**SAN FRANCISCO ELECTRIC
RELIABILITY PROJECT
(04-AFC-1)**

**INFORMAL DATA RESPONSE,
SET 9**

(Responses to Informal Data Request in: Soil and Water Resources)

Informal Data Request - January 4, 2006
Technical Area: **Soil and Water Resources**
Authors: **Mark Lindley and Vince Geronimo (PWA)**

This is in response to your request for a will serve letter for your project at the location shown on Figure I attached hereto.

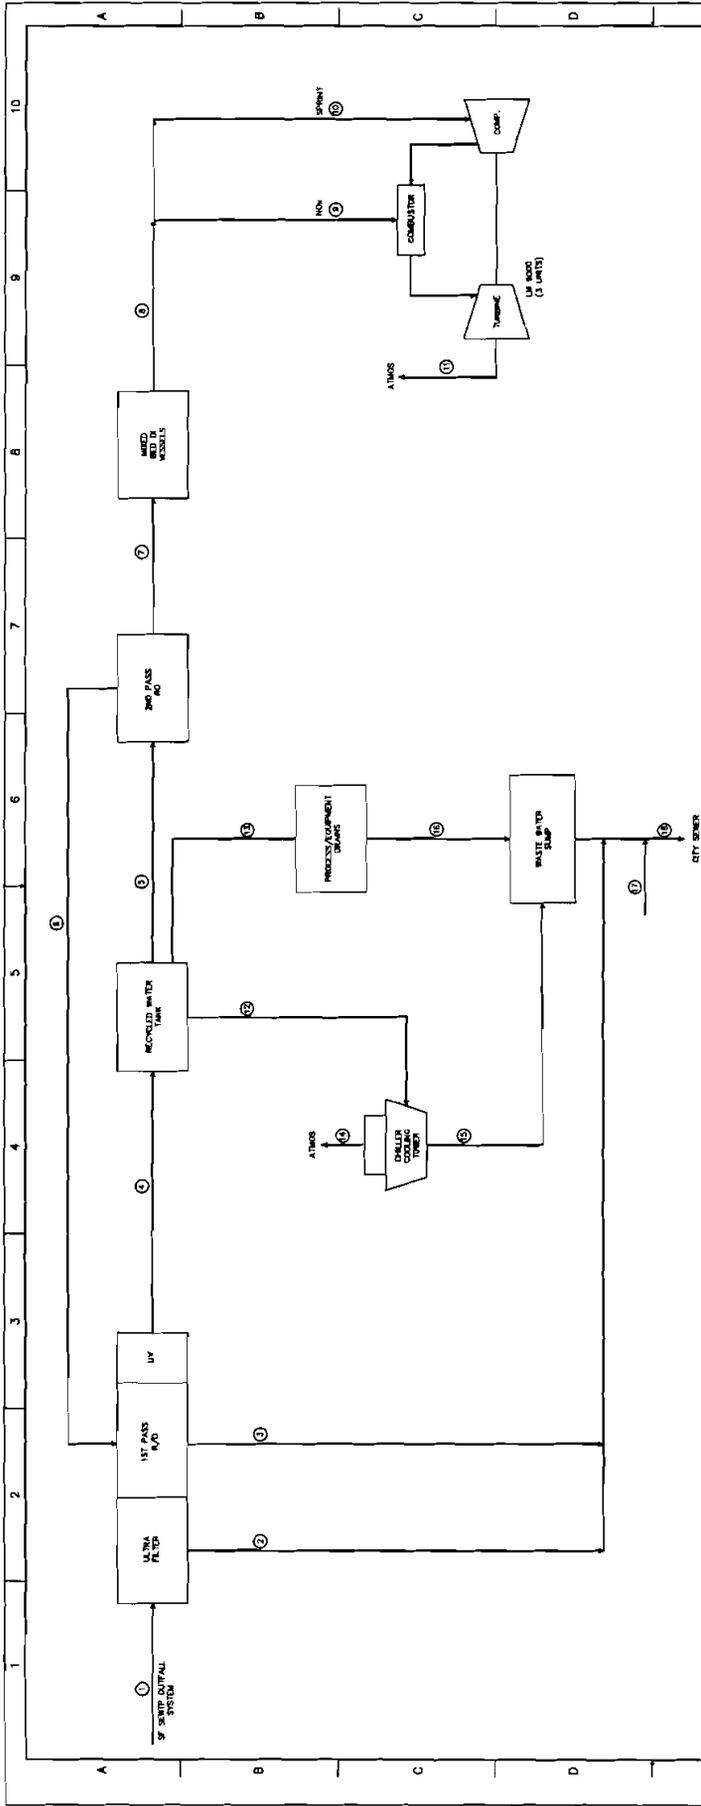
S&WR9-10 Provide a new Will-Serve Letter from SFPUC that identifies the new supply source. The letter should acknowledge the point of connection to existing SFPUC infrastructure.

Up to 500 gallons/minute of wastewater can be withdrawn from the combined sewer system at Third Street to provide process water supply for the SFERP recycled water treatment plant. The Southeast Water Pollution Control Plant can accept the discharge from the recycled water treatment plant; our discharge (and/or supply) will be less than 1% of the daily average flow.
